**SUBJECT: REVISION "A" TO TECHNICAL BULLETIN 212-05-201:
TAILBOOM BULKHEAD REINFORCEMENT**

No. 212-05-201

MODEL AFFECTED: 212

SUBJECT: TAILBOOM BULKHEAD REINFORCEMENT

Figure 1
Doubler Selection

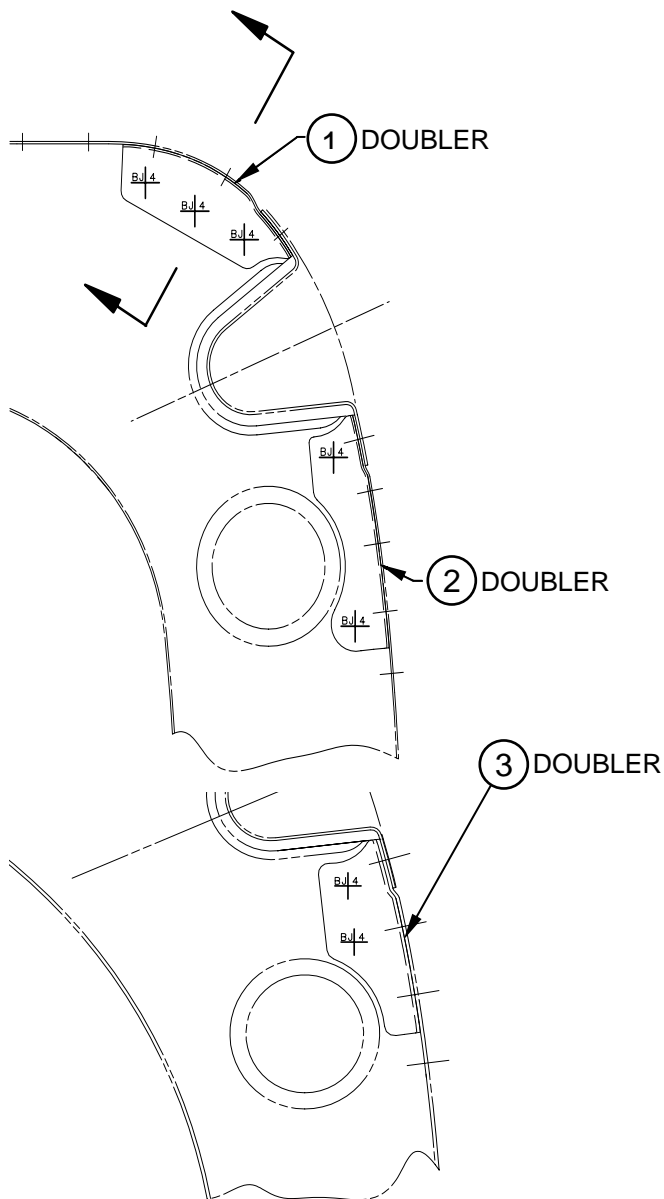
1. Make helicopter ready for maintenance.
2. Remove access panels at tailboom lower surface to gain access to bulkheads at Sta. 122.33, 143.28, 164.23, 185.18 and 194.30.
3. Select proper doubler for the location (refer to Figure 1) and remove existing rivets common to outside skin in the area covered by the doubler, noting rivet size, type and location for reinstallation.

Sta.	Bulkhead	A		B		C		D	
		UPPER	LOWER	UPPER	LOWER	UPPER	LOWER	UPPER	LOWER
122.33	205-032-821	-116	-118	-121	-125	-119	-123	-115	-117
143.28	205-032-820	-116	-118	-121	-125	-119	-123	-115	-117
164.23	205-032-827	-116	-118	-121	-125	-119	-123	-115	-117
185.18	205-032-828	-117	-121	-125	-129	-123	-127	-115	-119
194.30	205-032-824	-117	-121	-125	-129	-123	-127	-115	-119

Figure 2
Typical Installation

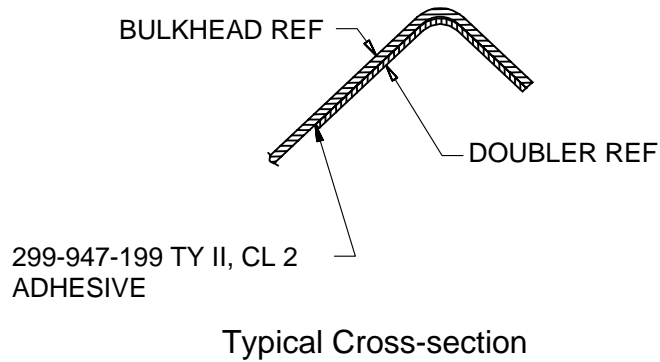
5. Position doubler selected at step 3 and transfer existing rivet holes. Attach with Clecos. Mark for two or three additional rivet holes, depending on location, through doubler and existing bulkhead as shown on Figure 2. Remove doubler and deburr all parts.
6. Lightly sand faying surfaces and apply adhesive (C-317). Attach doubler with existing-type rivets of appropriate length. All new rivets are MS20470AD4 rivets. Remove excess adhesive squeeze out and allow to dry.
7. Seal doubler edges using sealant (C-392) and apply a coat of primer (C-204).
8. Repeat above steps for all other applicable locations.
9. Reinstall access panels at lower surface of tailboom.
10. Make helicopter ready for flight.
11. Make an entry in helicopter historical records indicating compliance with this technical bulletin.

Note: Shape and size of doublers may vary. Maintain 2D edge distance on end fasteners. Fastener pattern typical
